**TOWN OF MOUNTAIN VILLAGE  
REGULAR DESIGN REVIEW BOARD MEETING**

**TO:** Mountain Village Design Review Board  
**FROM:** John Miller, Senior Planner  
**FOR:** Design Review Board Public Hearing; August 6, 2020  
**DATE:** May 20, 2020, *Updated July 24, 2020*  
**RE:** Staff Memo – Final Architectural Review (FAR) Lot AR-2

Grading  
and  
Drainage  
Plan

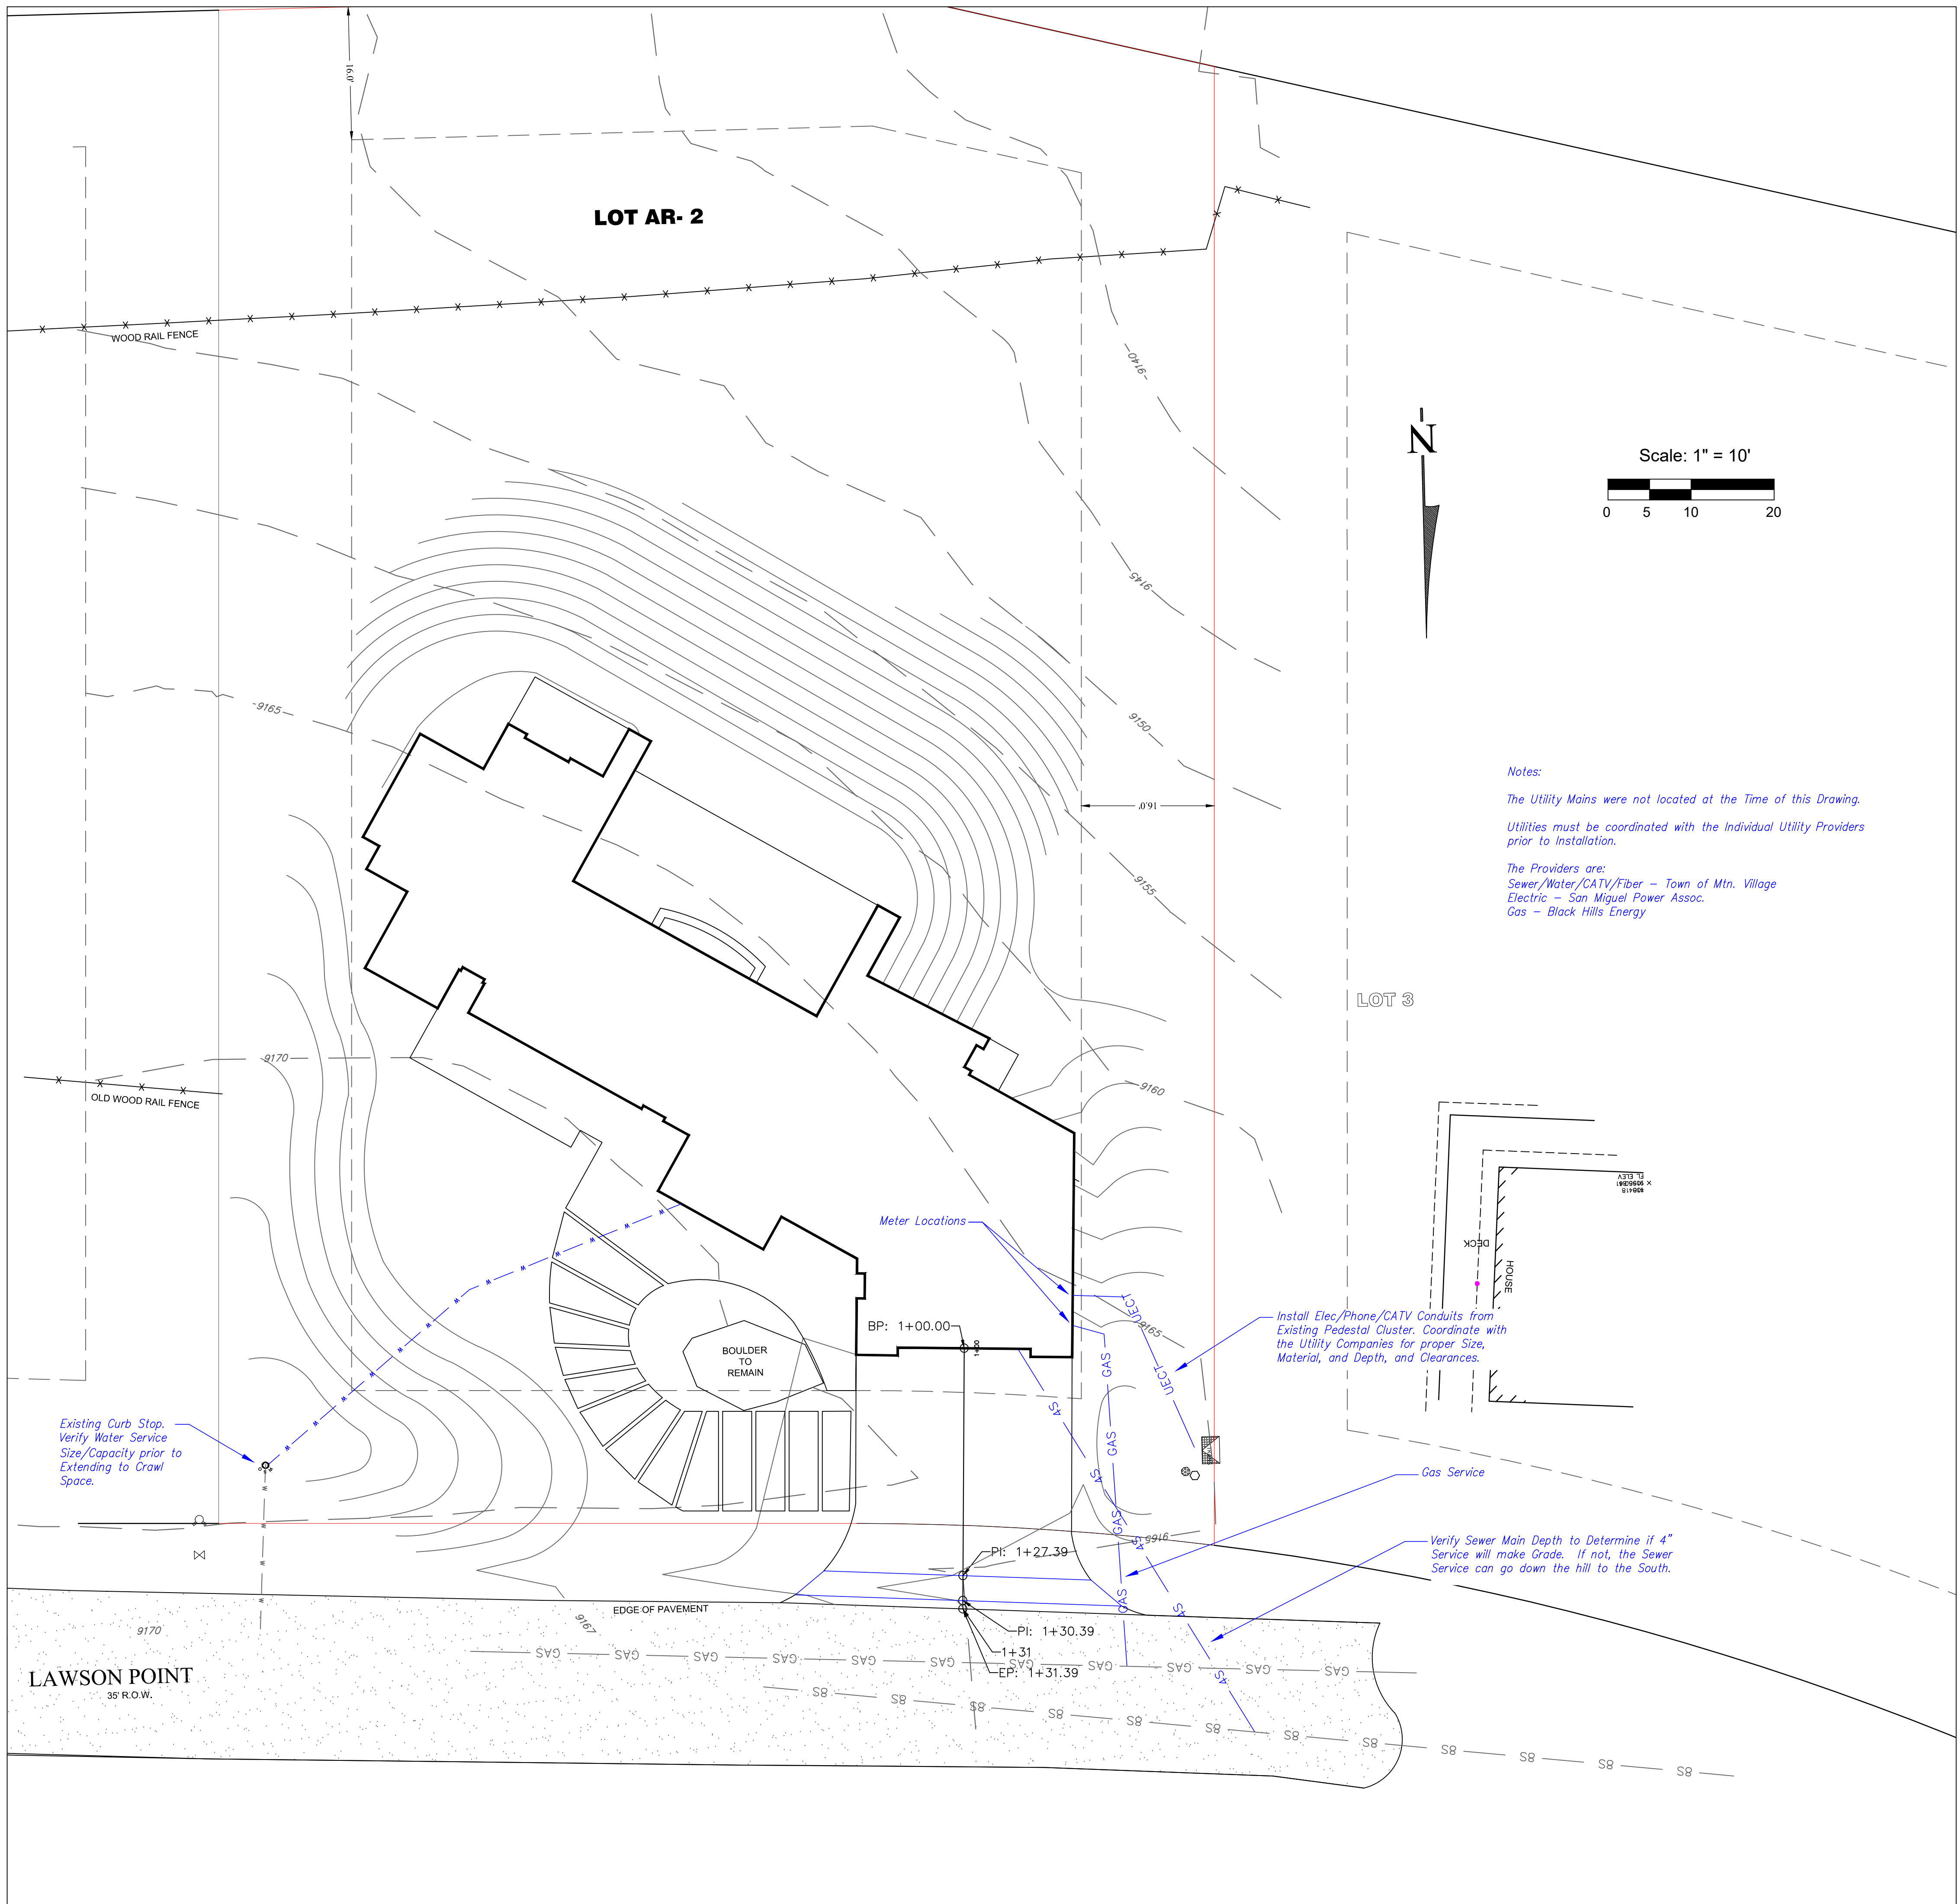
*Staff: The applicant has provided a grading and drainage plan documenting disturbed areas, cuts, fill, final slopes adjacent to the home, stormwater design including positive drainage from the proposed home, and specifications of the driveway. Staff would like to ensure as the project moves into construction that the stormwater generated from the impervious area of the driveway is captured in the ditch adjacent to the home rather than the roadway and that the ditch has adequate carrying capacity for any additional flows that are to be generated.*

**1 OVERALL SITE PLAN**  
SCALE: 3/32" = 1'-0"

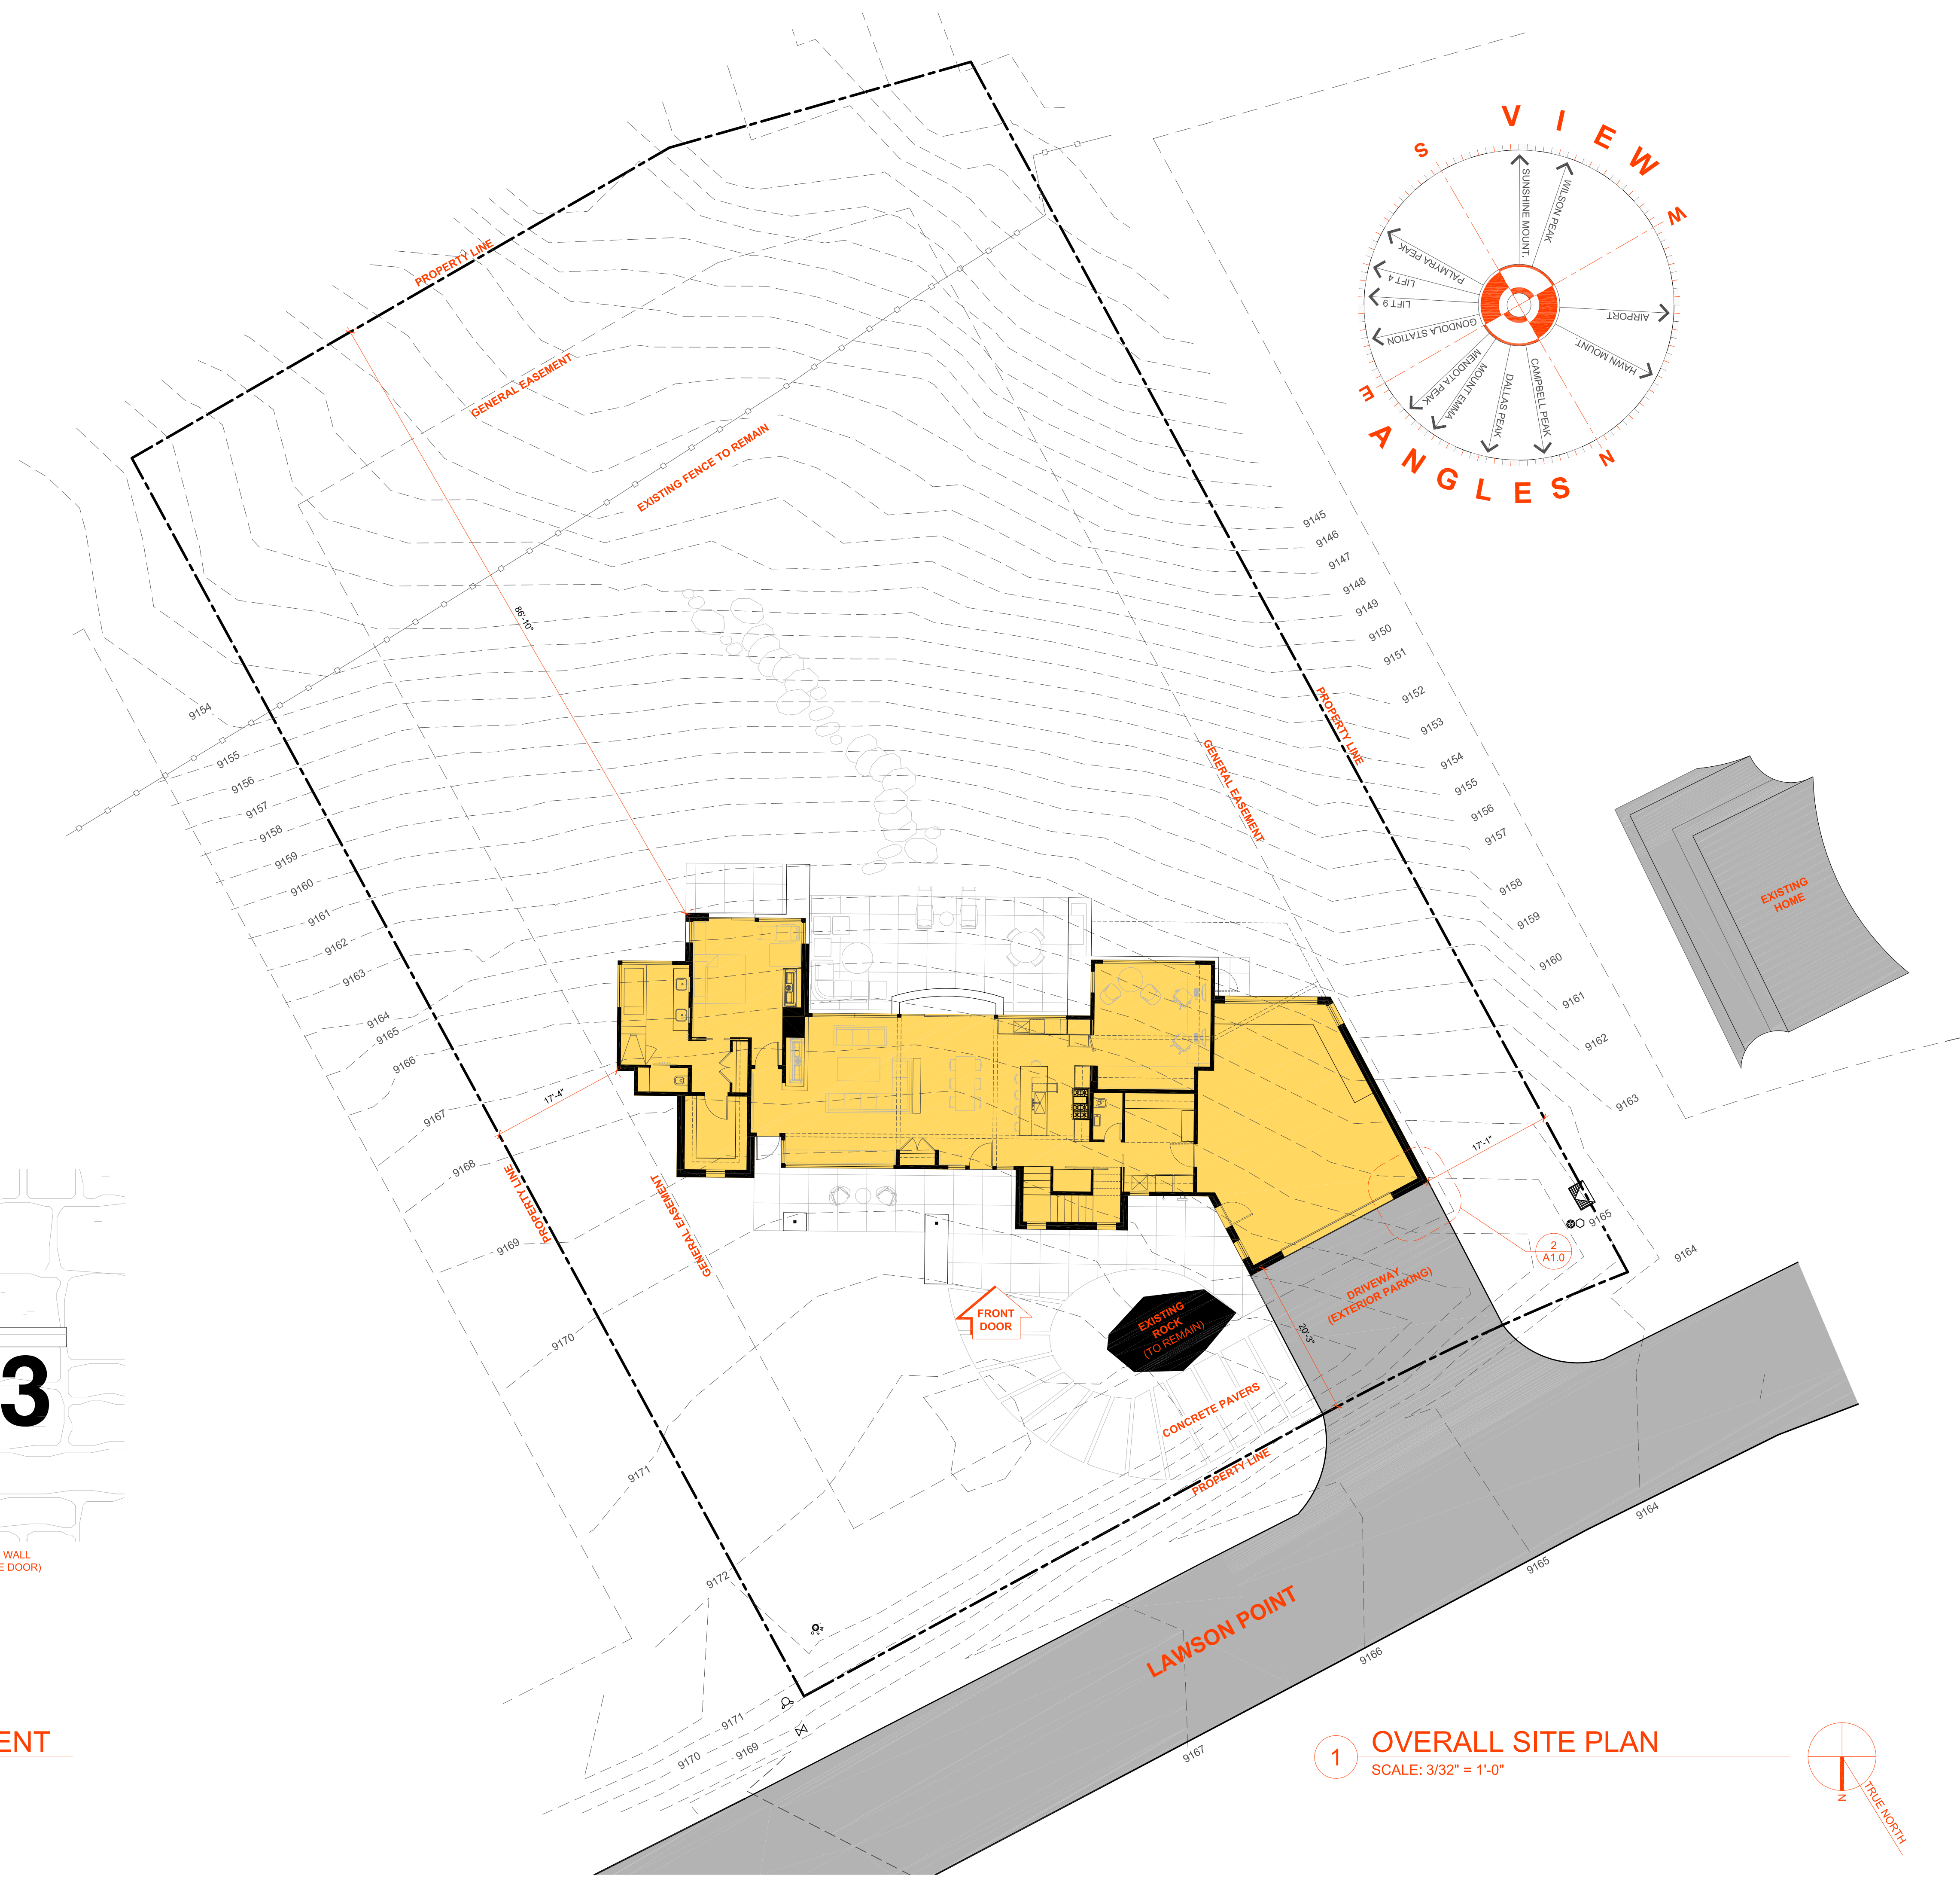
*Staff: The address monument has been revised from IASR to be located on the exterior façade of the home. The CDC allows for this if the numbers are within 20 feet of the roadway. As shown, the location of the numbers slightly exceeds the 20-foot distance requirement and will require a design variation from the DRB. Staff does not recommend approval of this and instead recommends the applicant revise the plans with the address monument located near the road within the GE.*
